UNITED STATES PATENT AND TRADEMARK OFFICE

APPLICATION NO.	FILING DATE	FIRST NAMED INVENTOR	ATTORNEY DOCKET NO.	CONFIRMATION NO.
10/623,781	07/21/2003	Jonathan E. Ricketts	17313	6104

Office Action Summary

DETAILED ACTION

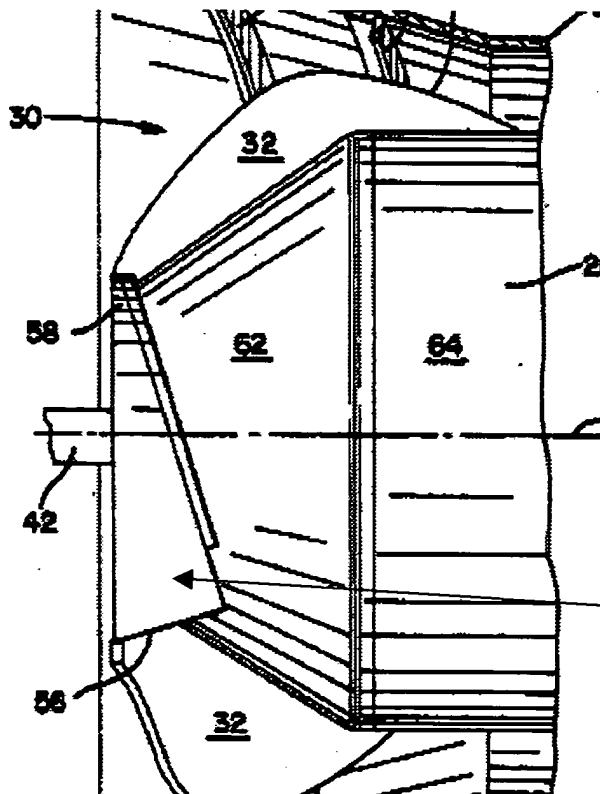
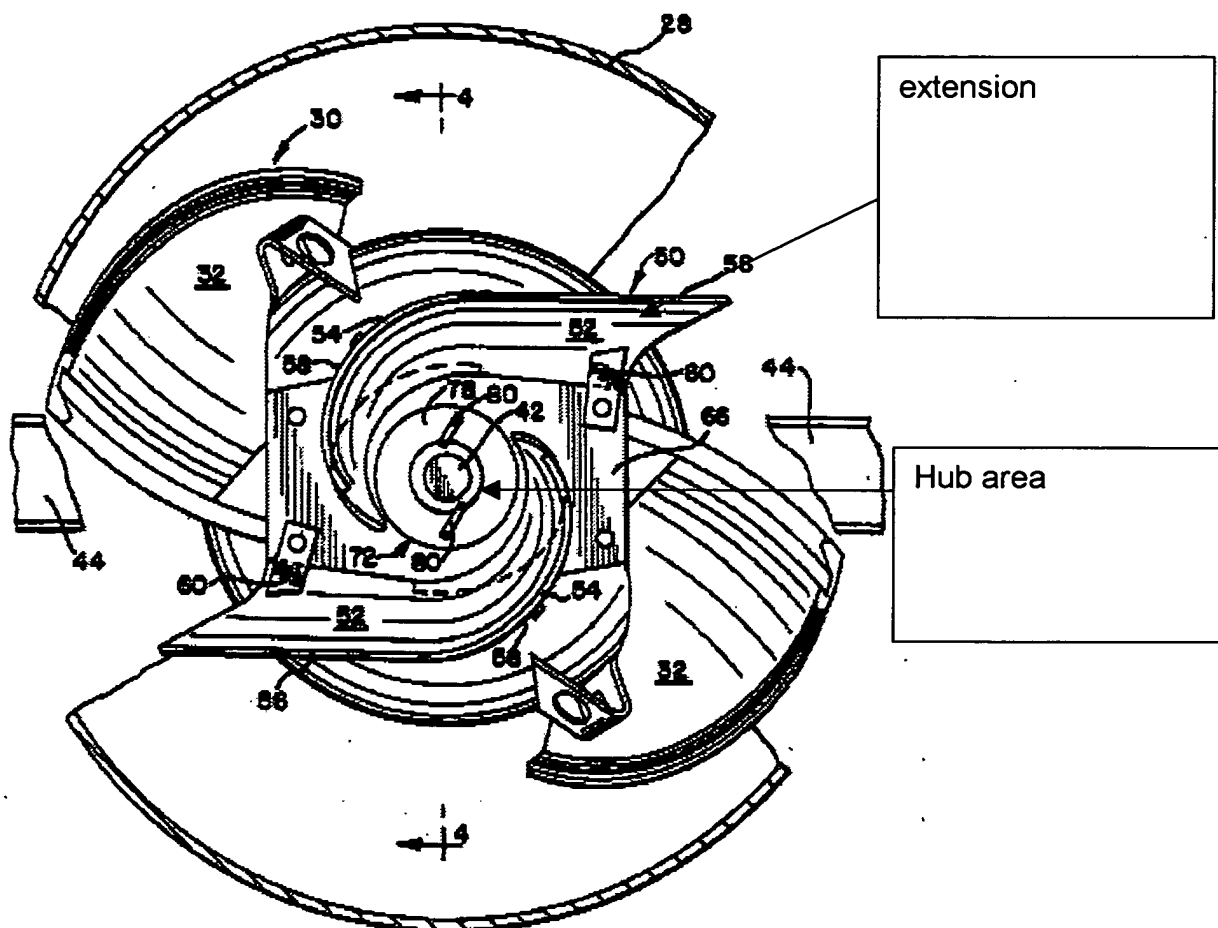
2. Claims 1-8 are rejected under 35 U.S.C. 102(b) as being anticipated by Tanis (5387153).

Tanis discloses:

An extension for a helical flight extending around a front inlet end of a rotor of a threshing system of an agricultural combine, the rotor being rotatable in a predetermined rotational direction about a rotational axis therethrough and the flight including a leading edge extending radially outwardly from the front inlet end of the rotor and a rearwardly facing helical crop flow surface extending rearwardly from the leading edge at a first predetermined angle of attack relative to a plane perpendicular to the rotational axis, for conveying crop materials from adjacent the inlet end of the rotor radially outwardly and rearwardly when the rotor is rotated, the extension comprising:

an elongate blade shape member removably mountable in radially outwardly extending relation along the radially outwardly extending leading edge of the flight, the blade shape member being disposed so as to be located forwardly of the leading edge of the flight with respect to the predetermined rotational direction along at least a

substantial portion of a radial extent thereof when mounted thereon the blade shape member having a leading edge having a curved swept back shape, and a rearwardly facing crop flow surface oriented at a second predetermined angle of attack less than the first predetermined angle of attack, such that when the rotor is rotated in the predetermined direction the member will accelerate crop material that comes into contact with the leading edge thereof radially outwardly and rearwardly onto the flight and generate a rearwardly directed air flow (as shown in fig 3, ref 56 shows a blade shape extension to a flight at the front inlet section radially outwardly & forwardly of a leading edge of the flights as claimed)

an elongate blade shape member removably mountable in radially outwardly extending relation along the radially outwardly extending leading edge of the flight
